Reference: Hanford Waste Vitrification Plant
DOE Contract DE-AC06-86RL10838
Fluor Contract 8457

NUMBER	REV	DATE	TITLE
DCN - #0067	1	3/24/94	DCN TITLE: **ROUTE 4S INTERSECTION FOR TOB PARKING LOT** "RELEASED FOR CONSTRUCTION"

DESIGN CHANGE NOTICE

DCN – 0067	REV 1	PAGE 1 OF 14
DCN TITLE: ROUTE 4S INTERSECTION FOR TOB PARKING LOT		DATE INITIATED: 2/9/94
		PACKAGE NO.: CWBS A130

HANFORD WASTE VITRIFICATION PLANT
DESIGN CHANGE NOTICE
DESCRIPTION OF CHANGE
ADDED ROUTE 4S INTERSECTION FOR
TOB PARKING LOT
BASE DOC. NO. H-2-117013
SHT/PG. 1 REV. 1
CR NO. 0975
DISCIPLINE: CIVIL
PREPARED BY:
DATE: 2/9/94
DISCIPLINE ENGINEER:
DATE: 2/9/94
DCN - 0067
REV. 1
PAGE 4

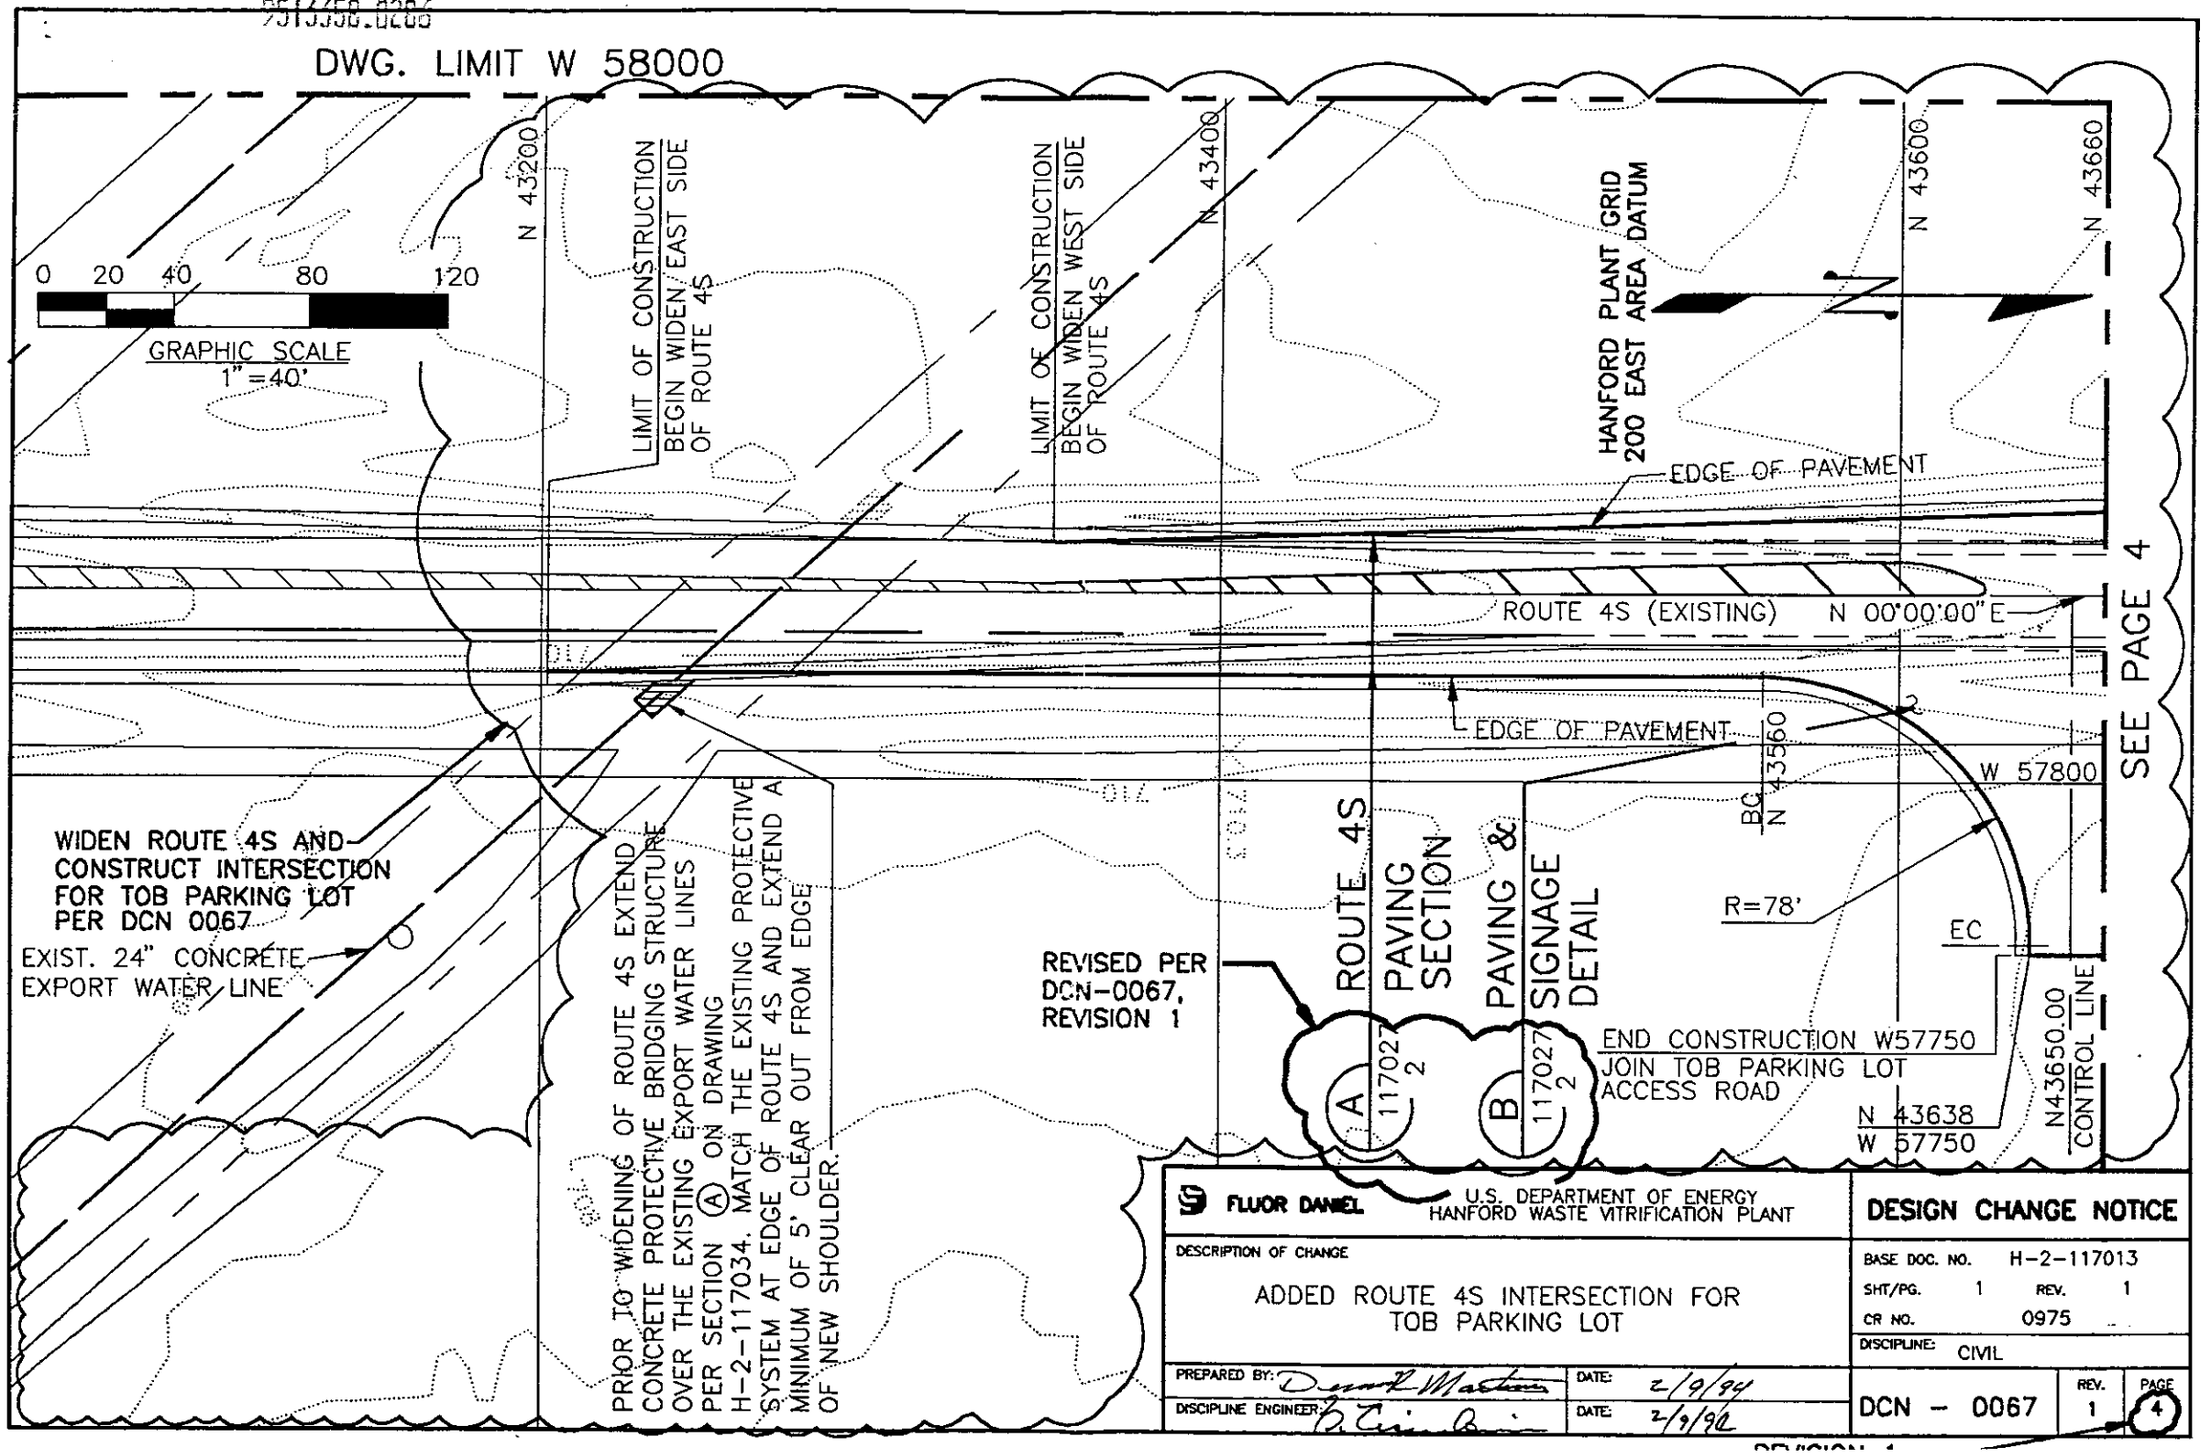
DOCUMENT NUMBER	SHT/ PAGE	REV NO	DOCUMENT NAME	INCLD Y/N	DESCRIPTION OF CHANGE
H-2-117013	1	1	CIVIL, ROADS AND SITE PREPARATION PLAN	Y	WIDEN ROUTE 4S FROM STATION N43202 TO STATION N44550 REV 1: REVISED SECTION AND DETAIL CALLOUTS, (DCN PAGE 4).
H-2-117013	2	(NEW SHT)	CIVIL, PLAN AND SITE PREPARATION PLAN	Y	WIDEN ROUTE 4S FROM STATION N43202 TO STATION N 44550 REV 1: REVISED SECTION CALLOUT (DCN PAGE 5) AND DELETED SIGNAGE DETAIL 14 AT STA 1+00, NORTHBOUND SIDE (DCN PAGE 6).
H-2-117027	1	1	CIVIL, HIGHWAY TURNOUT SITE PREPARATION DETAIL	Y	ADDED STRIPING AND SIGNAGE REV 1: SIGNAGE DETAIL NO. STATION DIRECTION DELETED (DCN PAGE 7): 6 20+00 NORTHBOUND 13 23+00 NORTHBOUND 14 23+00 SOUTHBOUND ADDED (DCN PAGE 7): 6&15 8+00 NORTHBOUND 13 18+00 NORTHBOUND ALSO, ADDED NOTE TO CLARIFY STATIONING REFERENCE.
H-2-117027	2	(NEW SHT)	CIVIL, HIGHWAY TURNOUT SITE PREPARATION DETAIL	Y	ADDED STRIPING AND SIGNAGE REV 1: SIGNAGE DETAIL NO. STATION DIRECTION ADDED (DCN PAGE 8): 13 15+00 NORTHBOUND 14 13+50 SOUTHBOUND ALSO, REVISED SECTION CALLOUTS AND ADDED NOTE TO CLARIFY STATIONING REFERENCE. DELETED (DCN PAGE 9): 14 1+00 NORTHBOUND ADDED (DCN PAGE 9): 6&14 2+00 SOUTHBOUND ALSO, REVISED SECTION CALLOUTS AND ADDED NOTE TO CLARIFY STATIONING REFERENCE.

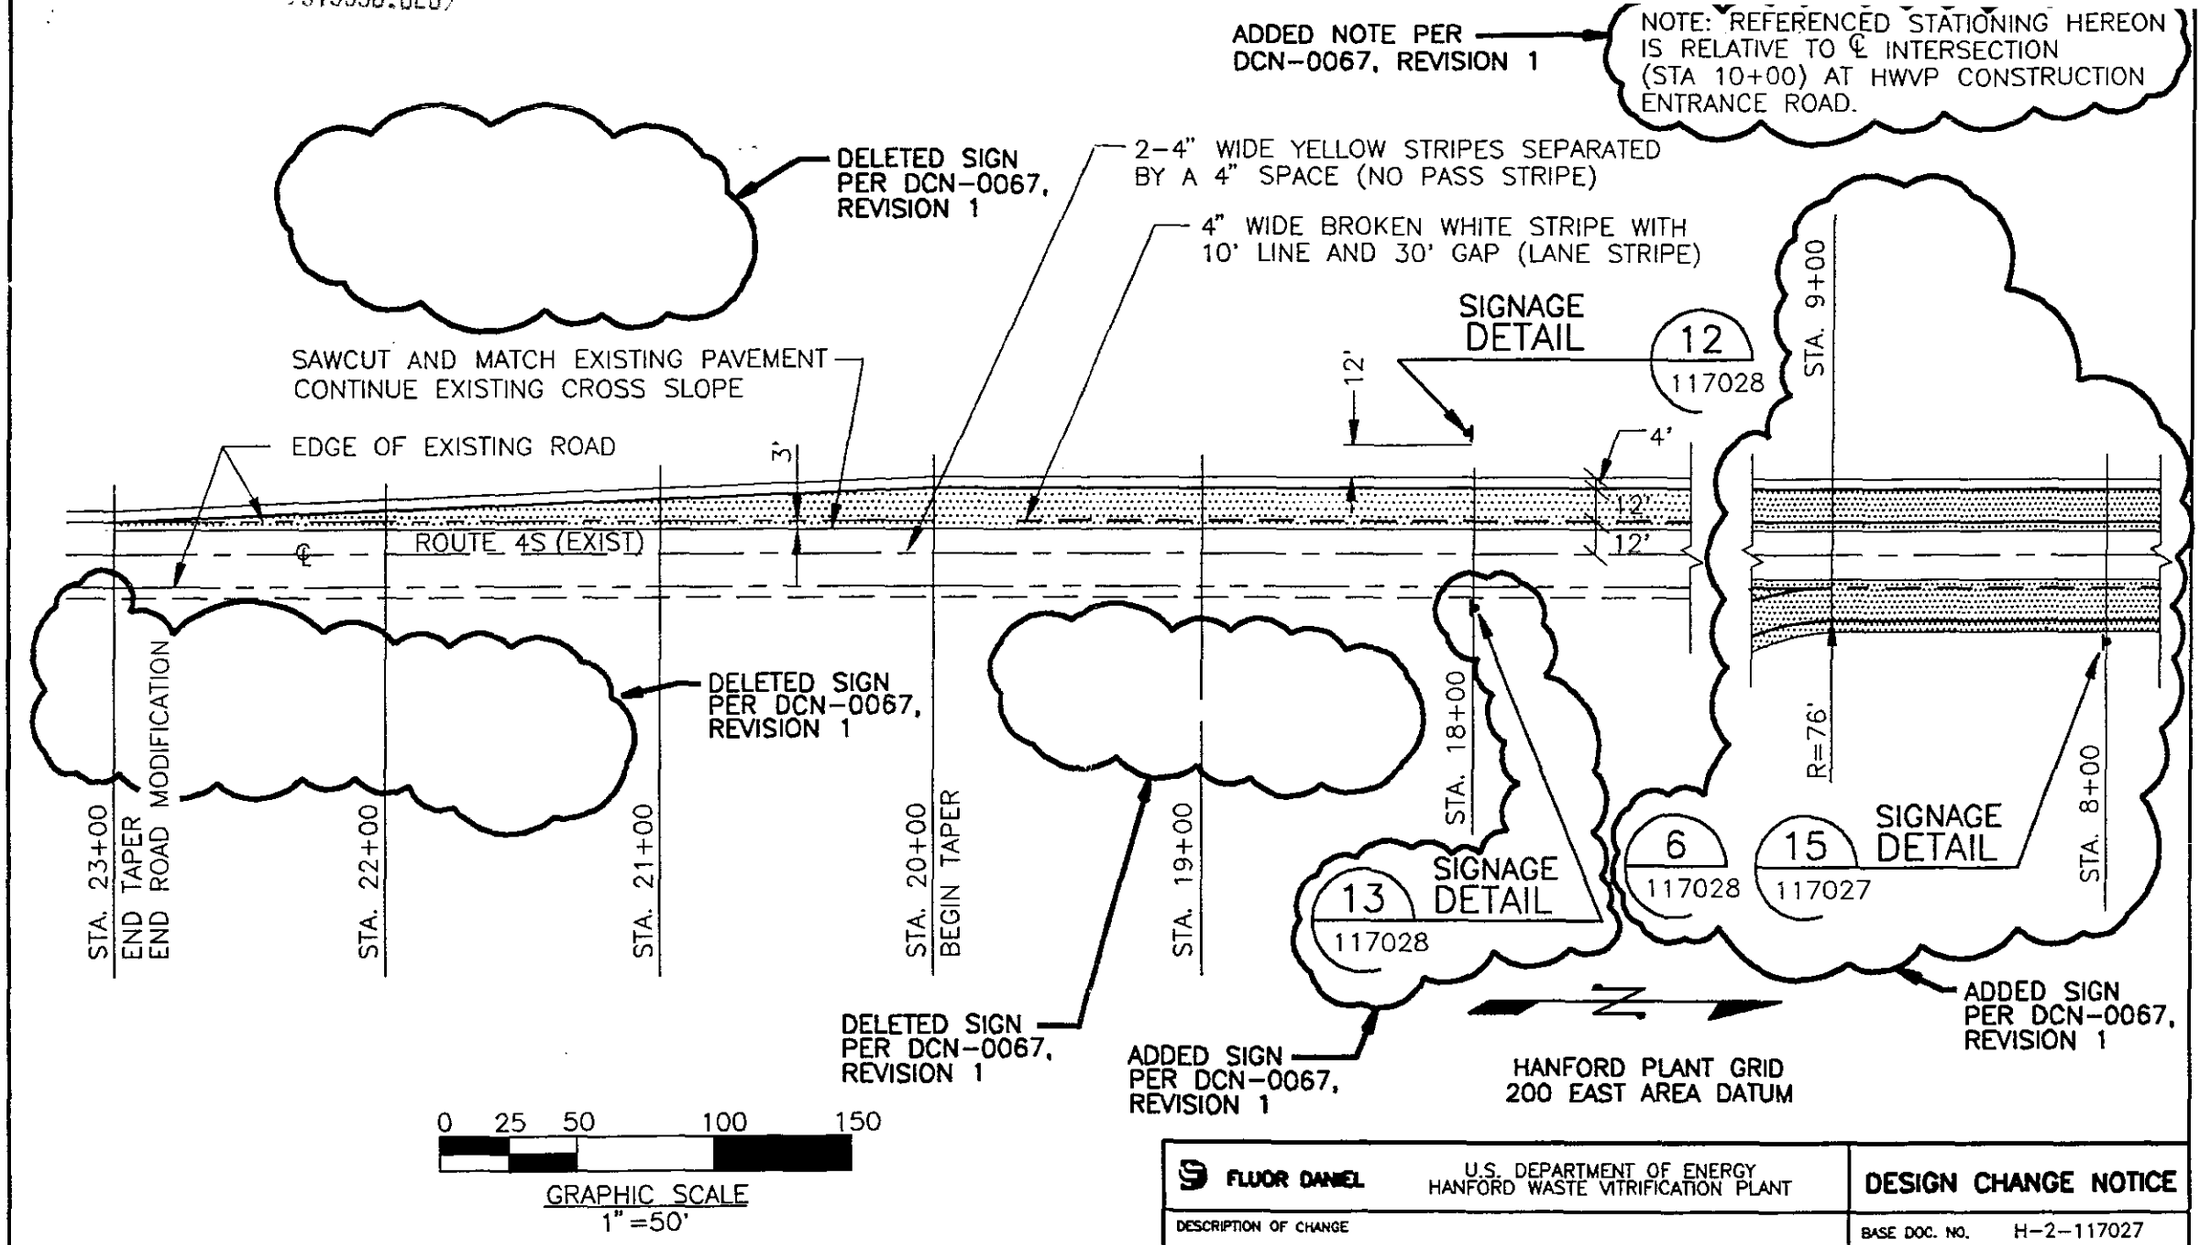
DOCUMENT NUMBER	SHT/ PAGE	REV NO	DOCUMENT NAME	INCLD Y/N	DESCRIPTION OF CHANGE
H-2-117027	2	(NEW SHT)	CIVIL, HIGHWAY TURNOUT SITE PREPARATION DETAIL	Y	(CONTINUED FROM PAGE 2) REV 1: REVISED SECTION CALLOUT (DCN PAGE 10). REVISED SECTION CALLOUT (DCN PAGE 11).
H-2-117028	1	1	CIVIL, SITE PREPARATION STRIPING AND SIGNAGE DETAILS	Y	ADDED SIGNAGE DETAILS REV 1: DCN-0067 PAGE 12, REVISED SIGN DETAIL 13 PAGE 13, REVISED SIGN DETAIL 6 PAGE 14, REVISED SIGN DETAIL 14

SECTION B
N.T.S.
117013
1

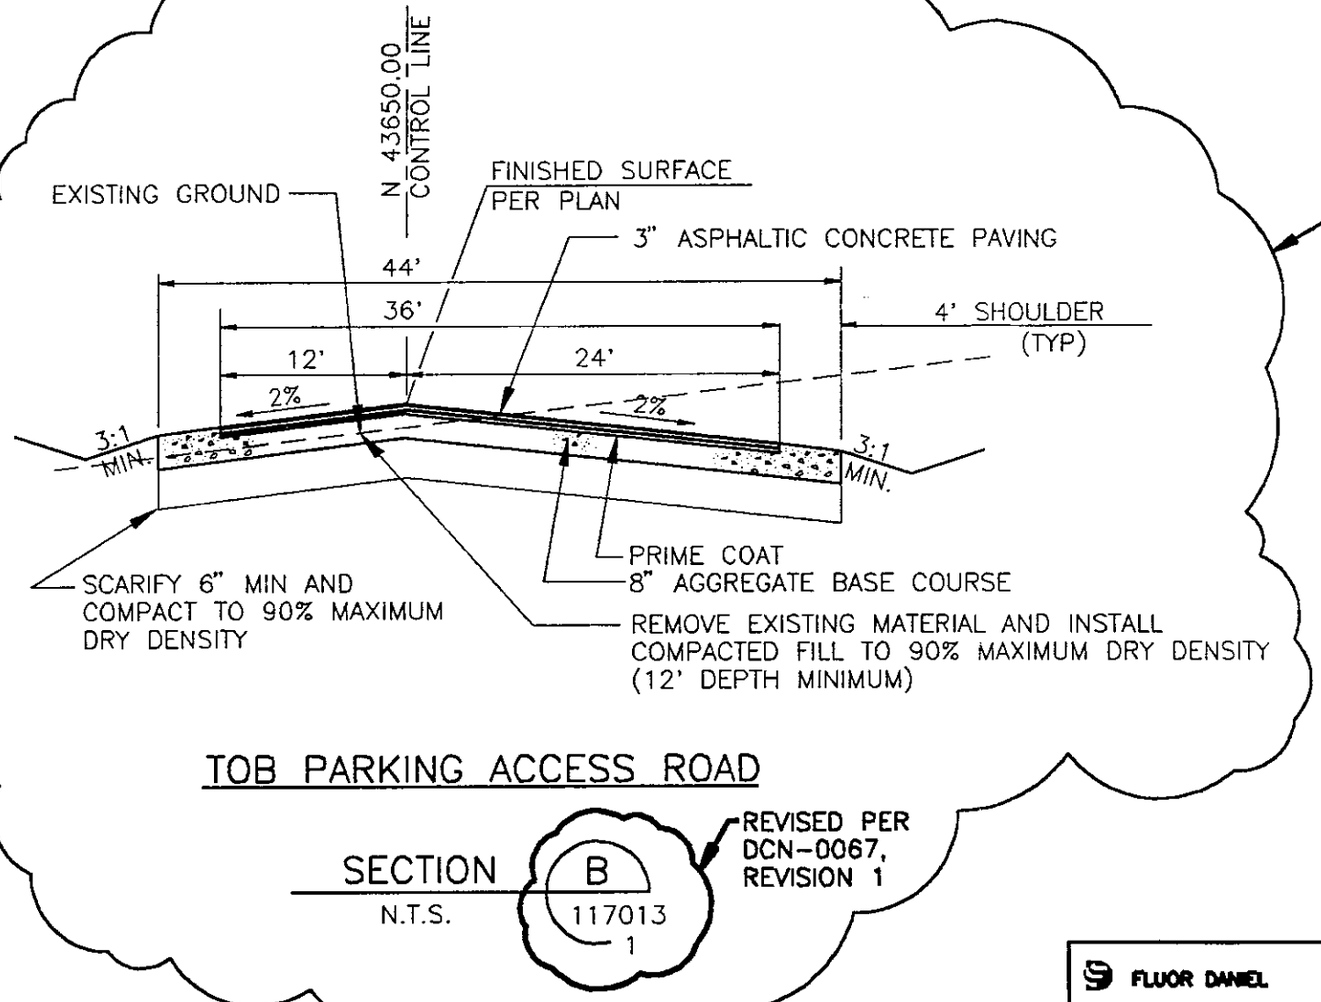
SECTION FOR TOB ACCESS ROAD
PER DCN 0067

REVISED PER
DCN-0067,
REVISION 1

SECTION A
117013
1,2

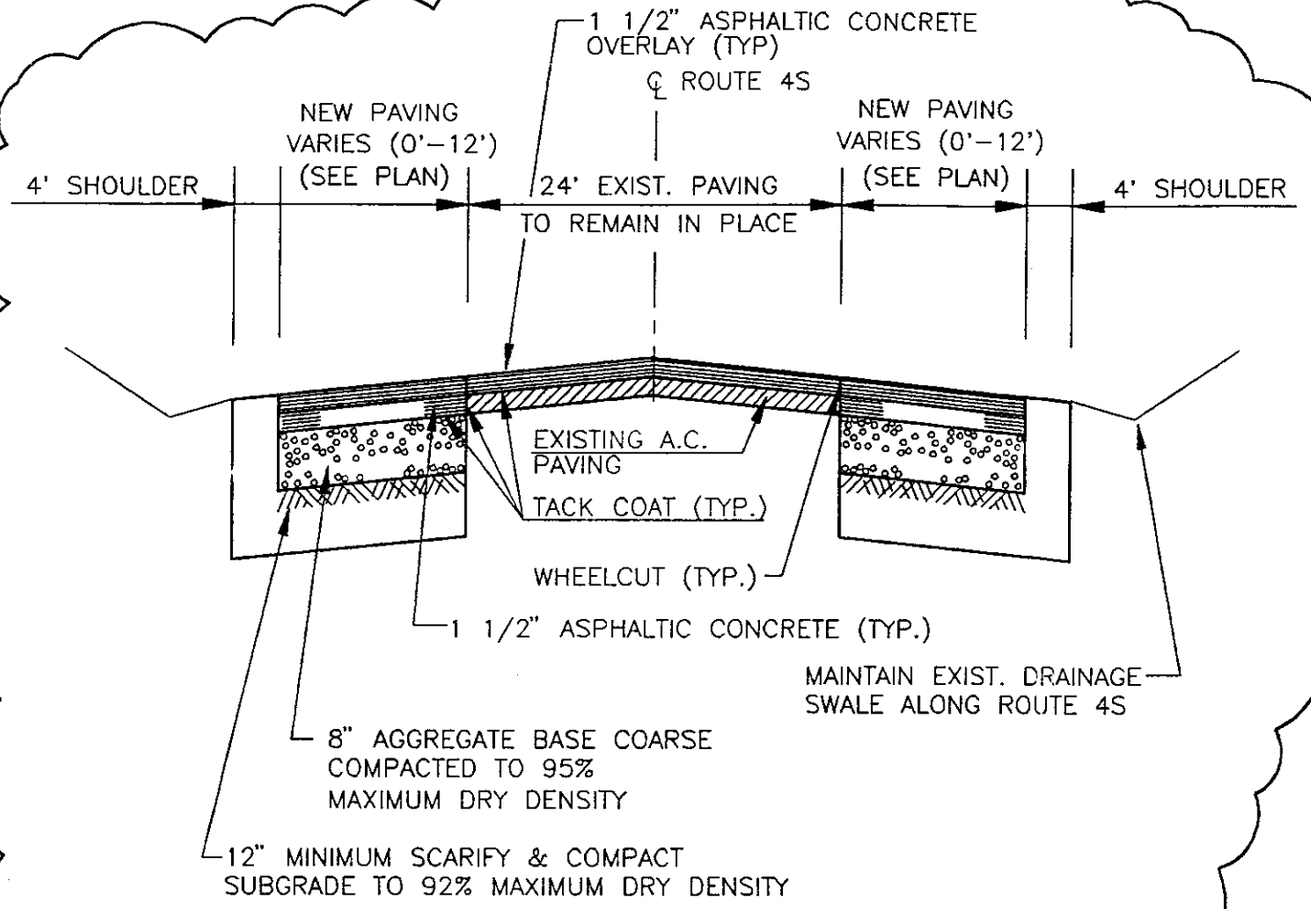
SECTION FOR ROUTE 4S WIDENING PER DCN 0067

REVISED PER DCN-0067, REVISION 1

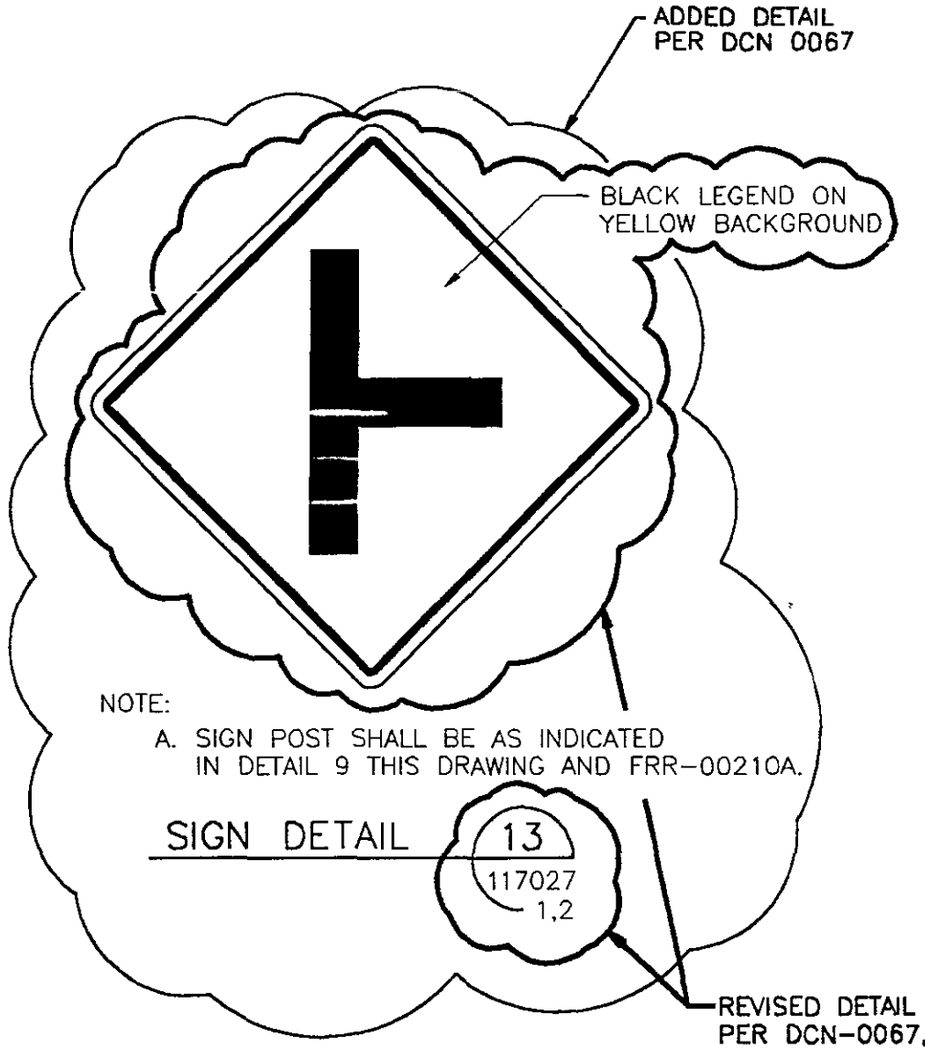
REVISION 1: REPLACE ROUTE 4S 35 MPH MANDATORY SPEED LIMIT SIGNAGE WITH 35 MPH WARNING SIGNS AND ADD "T" INTERSECTION AND "THRU TRAFFIC MERGE LEFT" SIGNS.
